# UNITED STATES PATENT AND TRADEMARK OFFICE

APPLICATION NO.	FILING DATE	FIRST NAMED INVENTOR	ATTORNEY DOCKET NO.	CONFIRMATION NO.
10/780,382	02/17/2004	James A. Cole	GP-304129	1821

**Office Action Summary**

## **DETAILED ACTION**

*Fig. 1*Claim 9:

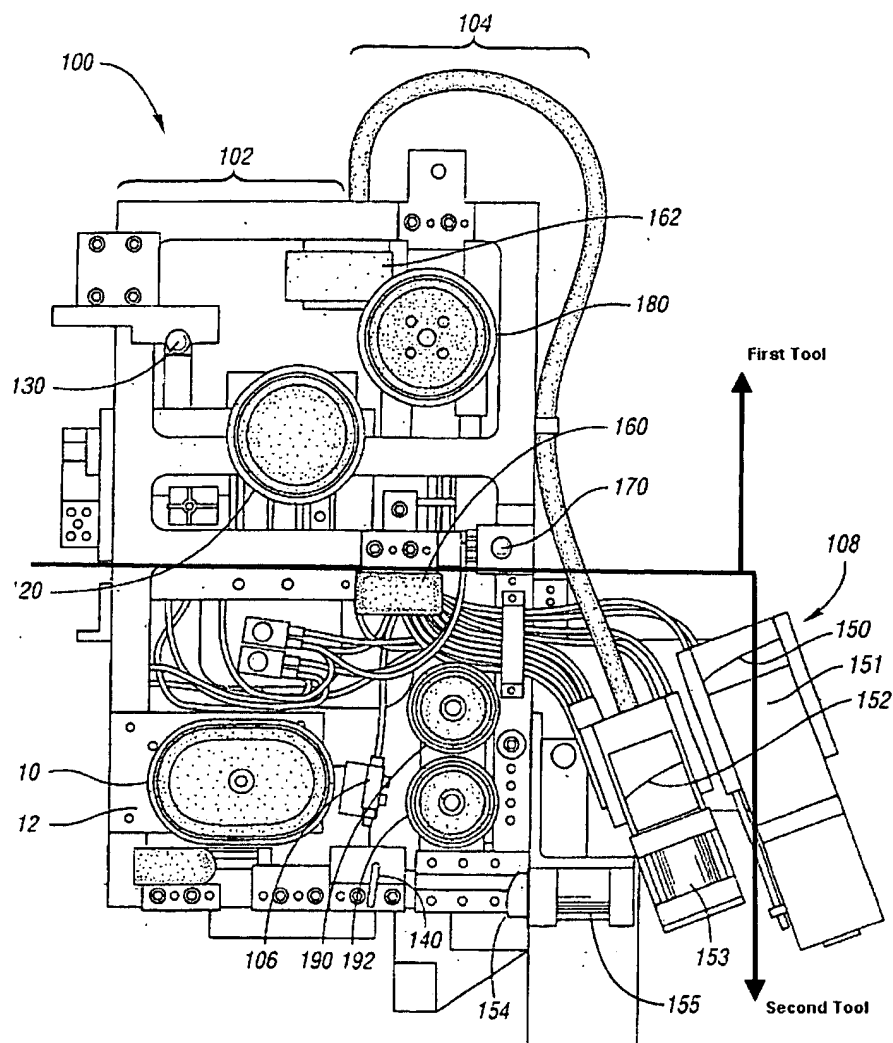
Roy teaches a control panel for controlling the movement of the body portions and the attachment on the body portions to the body panels (220 and col. 4, lines 1-25).

Roy teaches a tool assembly for setting a gap between a pair of panels including a first panel movably attached at a first mounting location and a second panel fixedly attached at a second mounting location, the panels being spaced apart to define a gap between the panels comprising, a first tool (see below) having a first body portion (104) adapted to be releasably attached to the first panel (30), a second body portion (102) adapted to be releasably attached to the second panel (20), and a pin (140) having a predetermined diameter (col. 3, lines 43-46), the first and second body portions and the pin being attached to and movable relative one another (by frame 100), a second tool (see below) having a first body portion(104) adapted to be releasably attached to the first panel (30), a second body portion (102) adapted to be releasably attached to the second panel (20), and a pin (140) having a predetermined diameter (col. 3, lines 43-46), the first and second body portions and the pin being attached to and movable relative one another (by frame 100), a connector member (frame 100) extending between the first and second tools, a control panel (220) attached to the frame (100) for controlling the movement of the body portions and the attachment of the body portions to the panels, whereby the first and second body portions are each attached to the respective first and second panels and the pin extends into the gap between the panels, the second body portion is moved relative to the first body portion until the first and

second panels contact the pin thereby setting the gap at the predetermined diameter  
(figure 3 and col. 4, lines 14-65).
